Planning Commission Regular Meeting

Monday, January 26, 2026, 6:30 PM
106 Center Street

ADDITION & REMODELING FOR:
BENNETT RESIDENCE
150 BELL STREET
EXCELSIOR, MN

4 SIDE ELEVATION
2 SCALE: 1/4" = 1'-0"

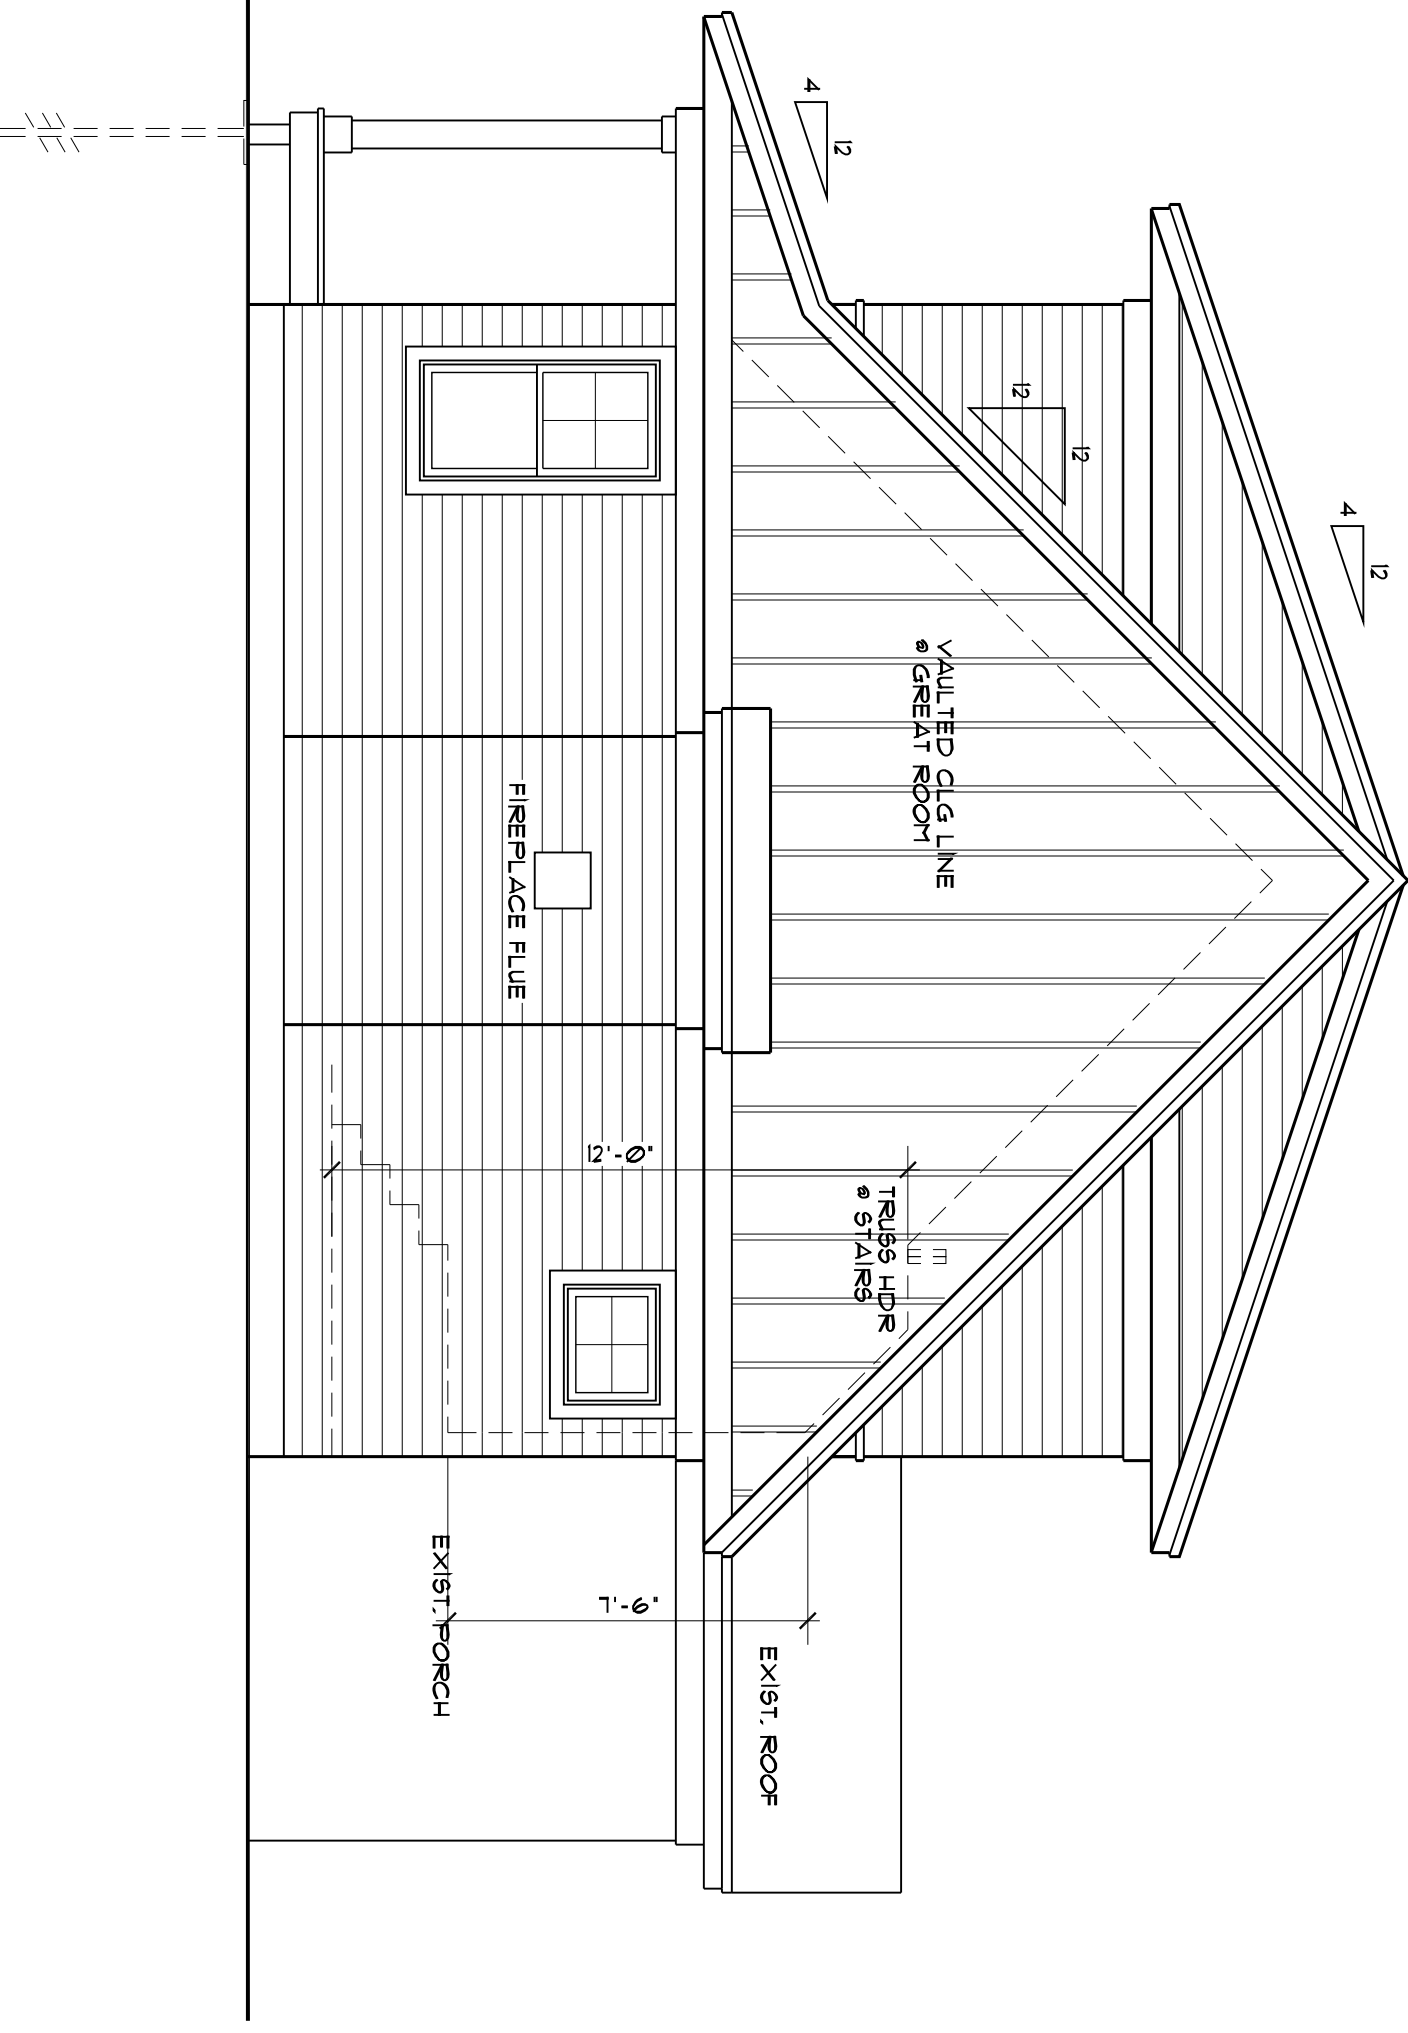
Generally, the height, massing and scale of the proposed house second level addition seem compatible with neighborhood context. By keeping the second story plan space smaller than the first, the shed dormer roof forms are inset from the ends enough to give an appearance of a 1-1/2 story massing that seems compatible with neighboring structures.

1 EAST ELEVATION
A7 1/4" = 1'-0"
0 2' 4' 8'

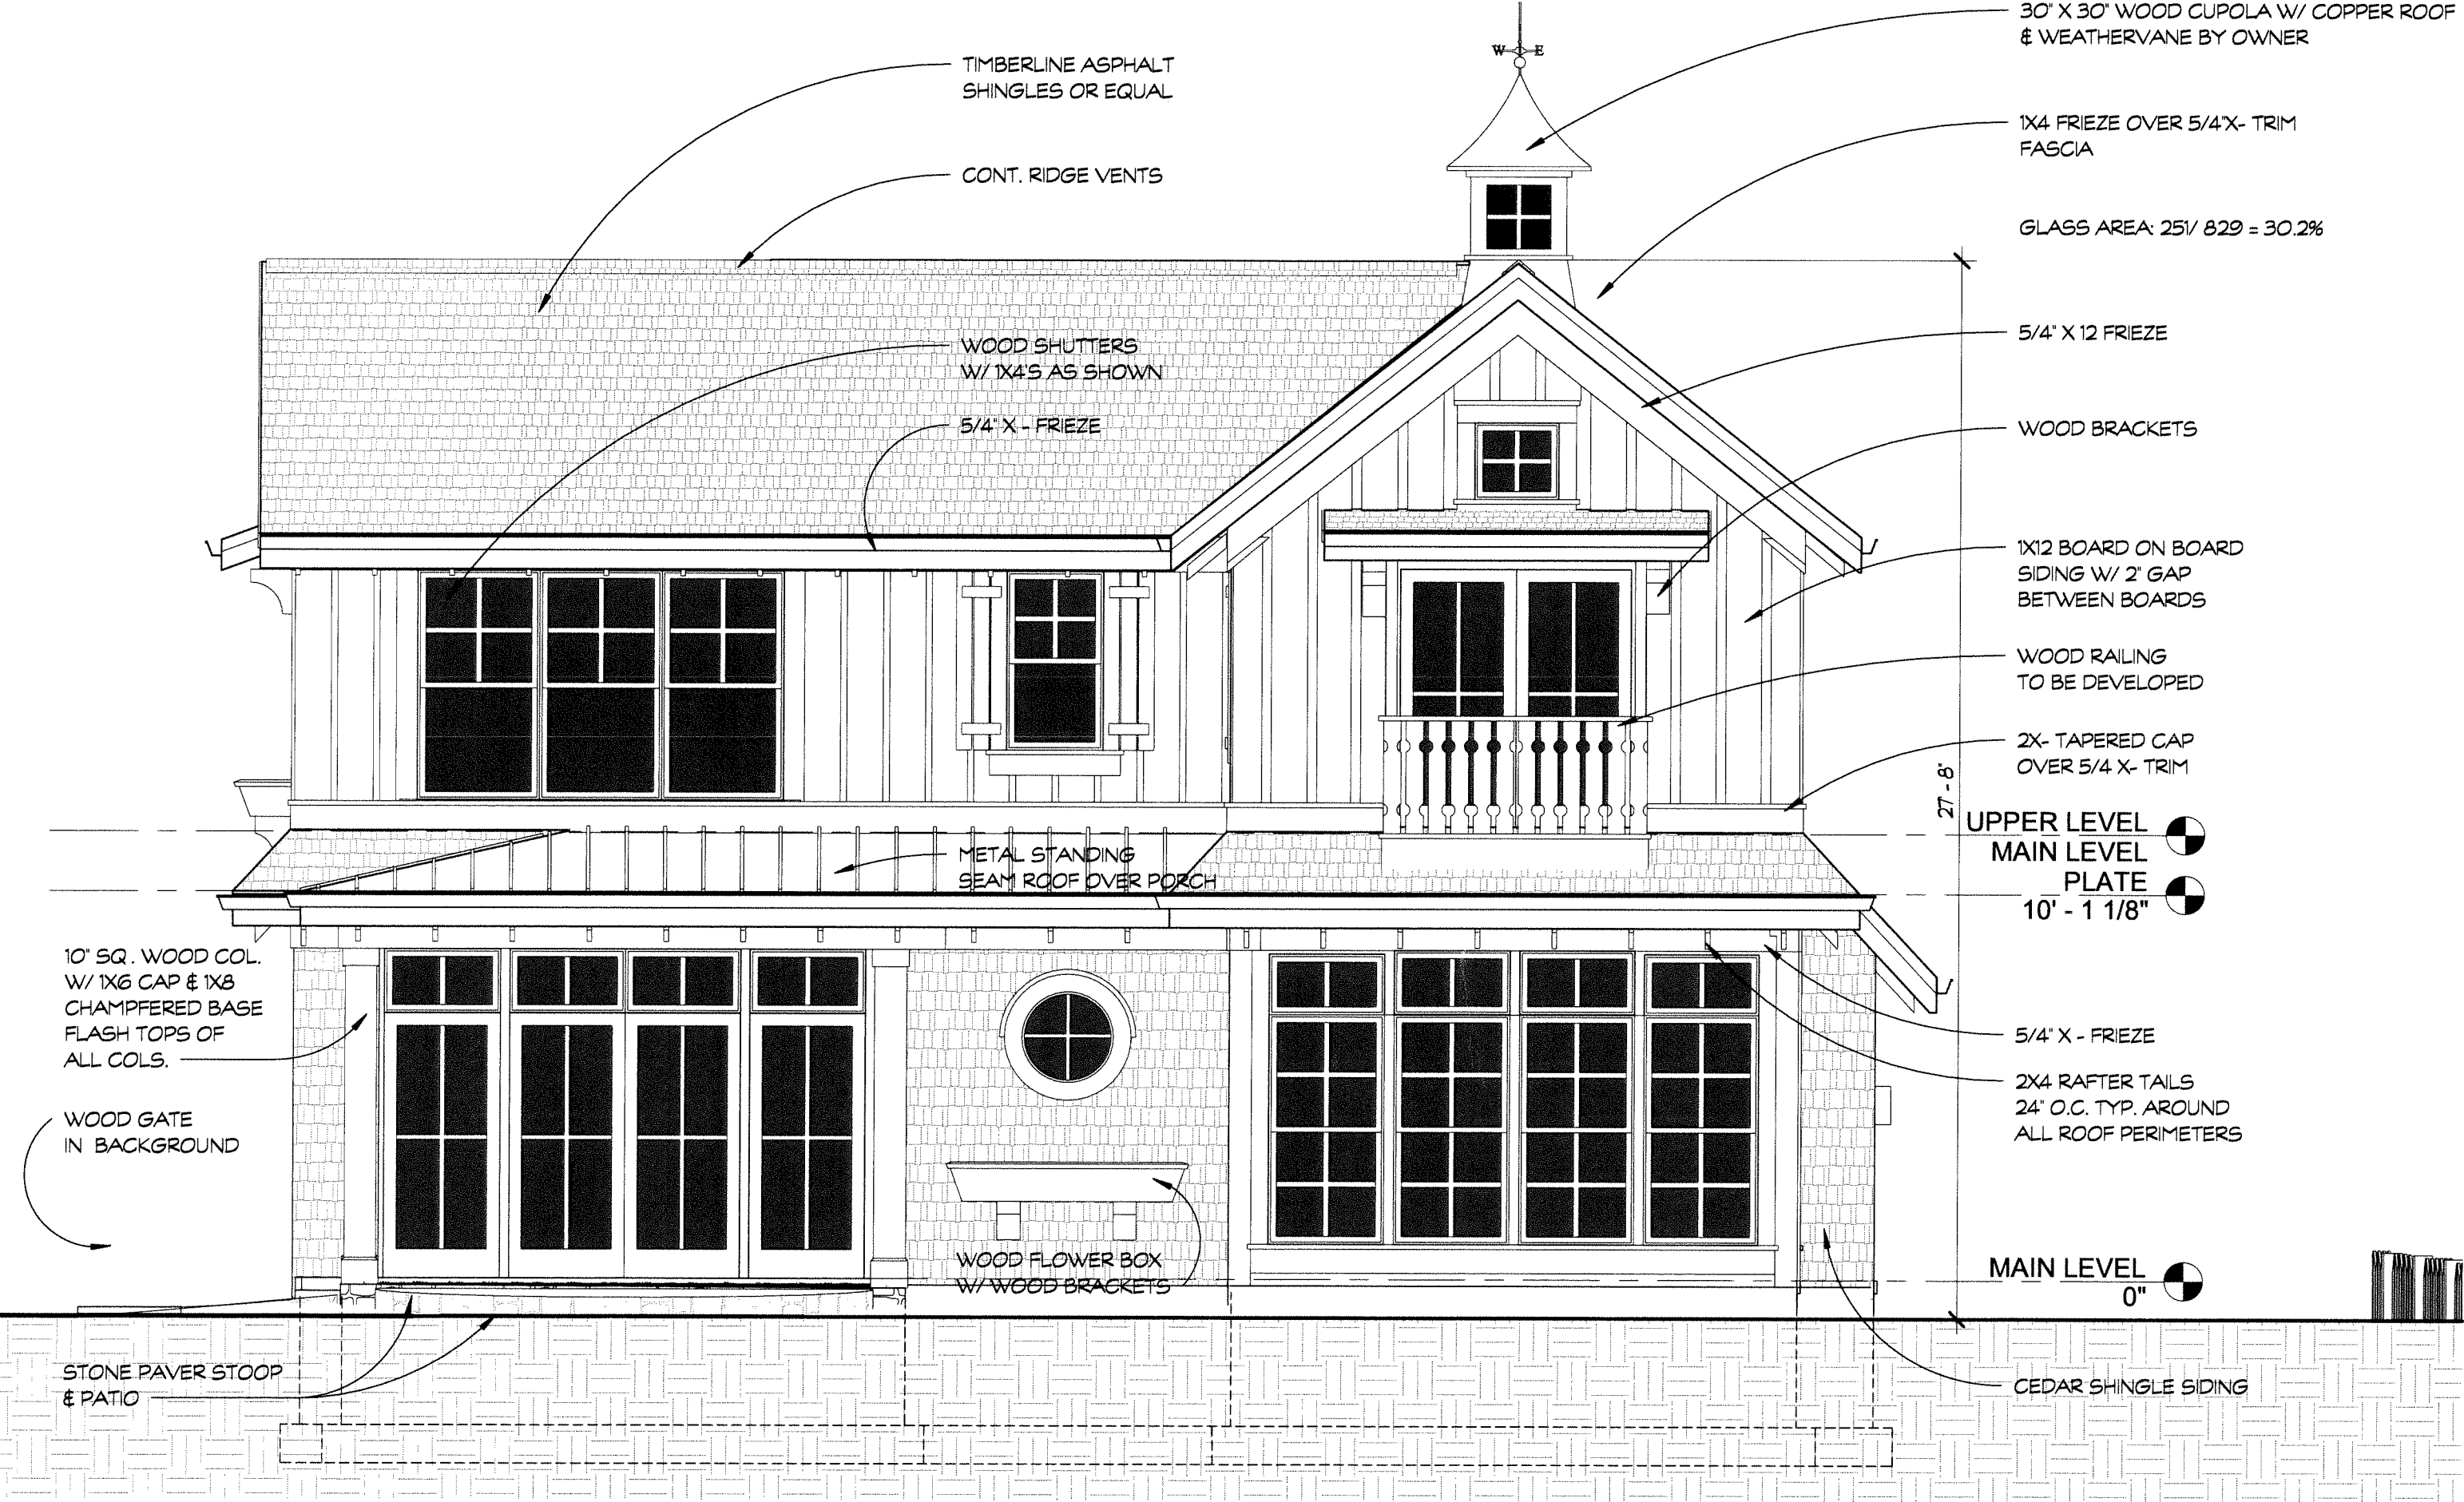
Garage: The proposed home includes plans for an attached garage that faces West Lake Street. The door to the two car garage is 18 feet by 6 feet and is 128 sq ft. Standards are met except for the size of individual garage doors. A garage door is required to be no greater than 64 sf and no taller than 8'. The plans propose one 128 sq ft garage door. The proposed design of the garage door includes wood overlays that mimic the look of two individual doors.

the proposed garage being only 16' in width. Fitting two doors would result in smaller openings. The design meets the intent of the ordinance. The Commission should determine if additional architectural detail will better meet the intent of the ordinance.
